FITZSIMONS GATEWAY MULTIFAMILY | SITE PLAN

LOT 2, BLOCK 1 FITZSIMONS PROMENADE SUBDIVISION FILING NO. 1 AMENDMENT 1
LOCATED IN THE NORTHWEST 1/4 OF SECTION 1, TOWNSHIP 4 SOUTH, RANGE 67 WEST OF THE 6TH P.M.,
CITY OF AURORA, COUNTY OF ARAPAHOE, STATE OF COLORADO

AMENDMENTS

DATE:
08/24/22 - SITE PLAN 01
10/17/22 - SITE PLAN 02
11/23/22 - SITE PLAN 03
12/19/22 - SITE PLAN 04
02/13/23 - SITE PLAN 05
05/17/23 - MINOR AMD 01-1
12/08/23 - MINOR AMD 01-2
01/30/24 - MINOR AMD 01-3
12/12/24 - MINOR AMD 02-1
01/06/25 - MINOR AMD 02-2

NORTH AMENITY DECK LANDSCAPE PLAN

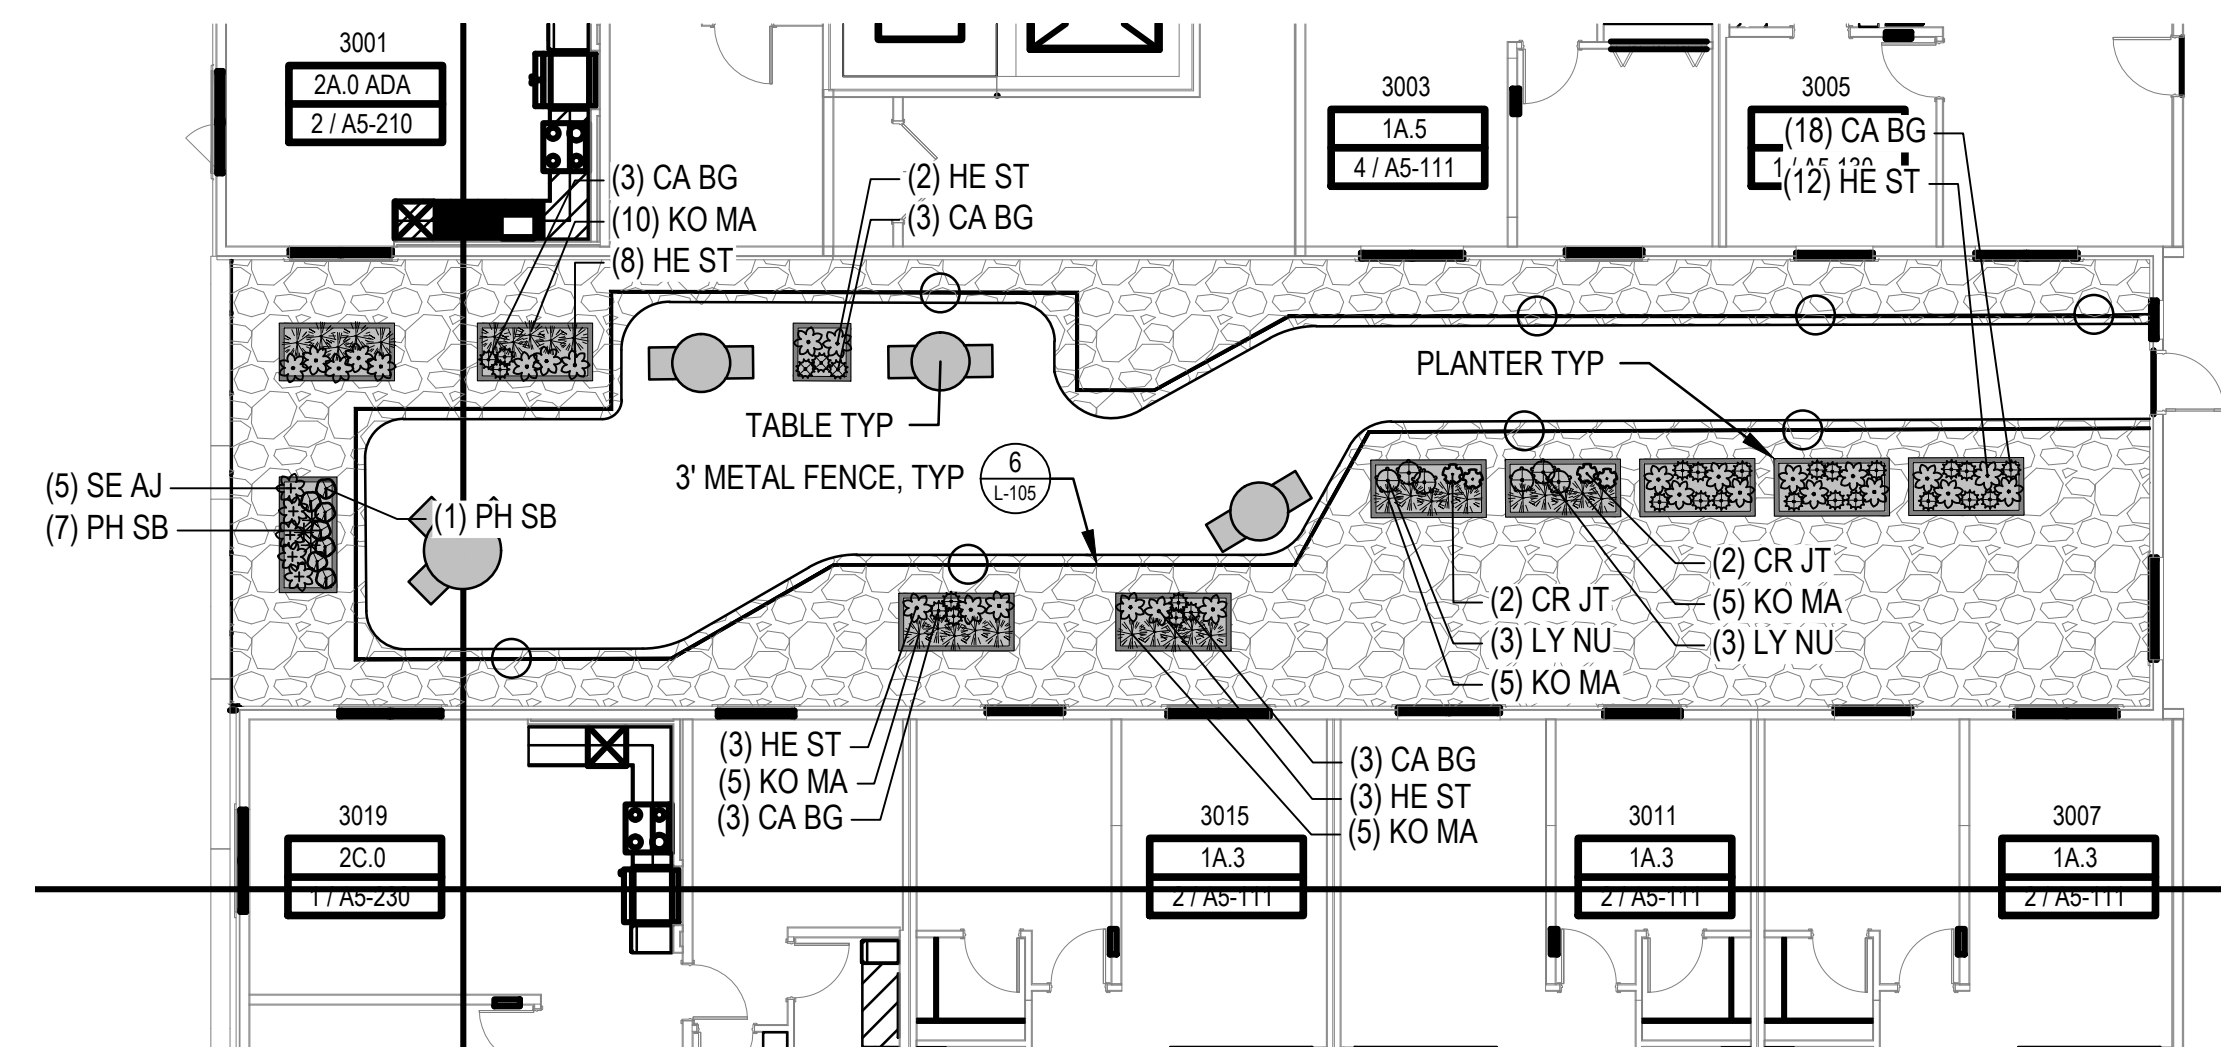
- AMENITY DECK LANDSCAPE PLANTERS AND FENCING REVISED PER COMMENTS RECEIVED DURING BUILDING PERMIT REVIEW. COBBLE REMOVED AND PLANTERS MOVED FURTHER FROM EDGE, FENCING DETAIL REVISED. UPDATES SHOWN ON LANDSCAPE ENLARGEMENTS, LANDSCAPE DETAILS, LEVEL 3 PHOTOMETRIC PLAN.

1
SITE LIGHTING PHOTOMETRIC
SCALE: 1" = 30'-0"

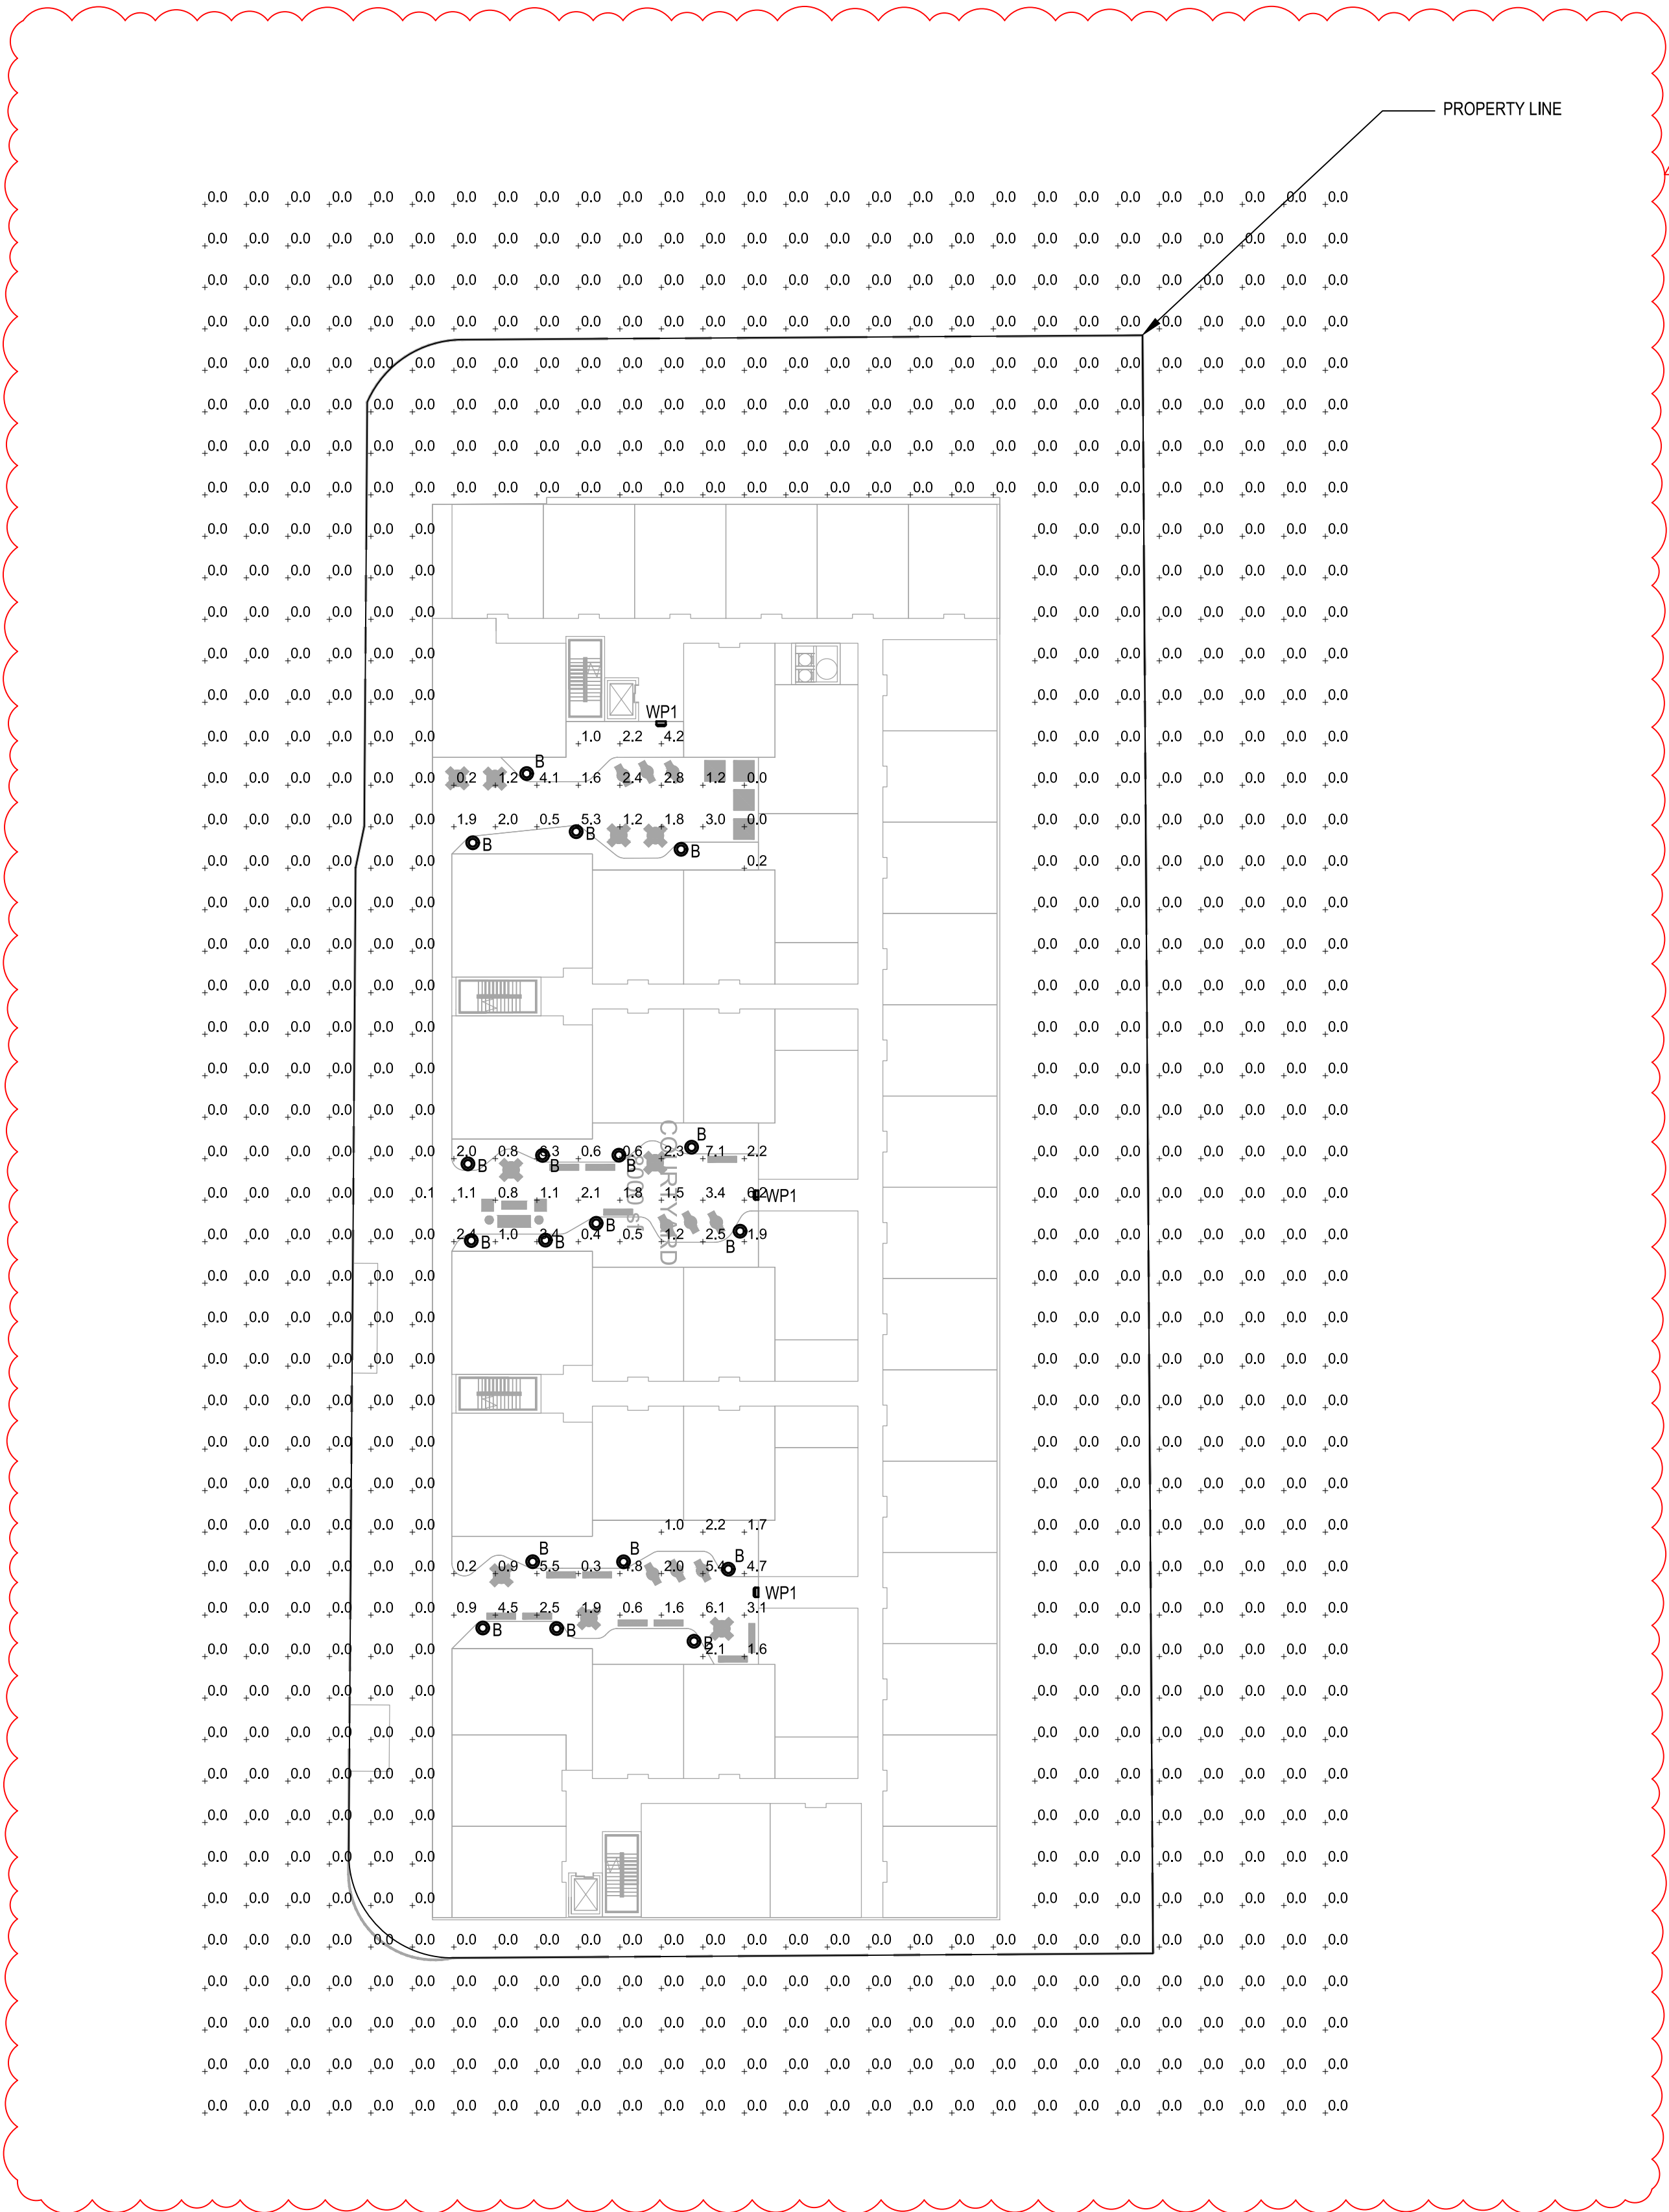
- LIGHT FIXTURES HAVE BEEN SWAPPED IN THE PLAZA ALONG COLFAX. WALL SCONCES, BOLLARDS, AND WALL PACKS HAVE BEEN SWAPPED FOR COMPARABLE FIXTURES FROM DIFFERENT MANUFACTURERS. MINOR CHANGES IN PHOTOMETRY, RESULTING FROM FIXTURE SWAPS ARE SHOWN

2
LIGHTING PLAN HAS NOT CHANGED. SOME FIXTURE SPECIFICATIONS REVISED.
